Proper Securement of Ballistic Skirts

Mounting Pins
(seal replaces locking pin)

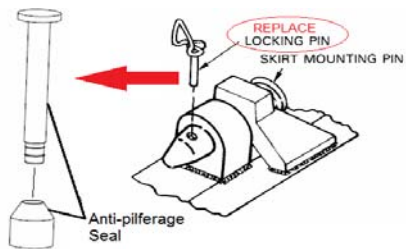
1. Replace six spring locking pins on the end of the skirt mounting pins with approved anti-pilferage seals.
2. The approved anti-pilferage seals for purchase are identified as NSN 5340-01-260-9935 and cost roughly \$2.
3. Ensure vertical skirt hinge pins are present and secure.
4. Ensure the bolt on the swing latch on skirt one is tensioned properly.
5. See TMs 9-2350-264-20-1-1 or 9-2350-388-23-1-2 for more details.
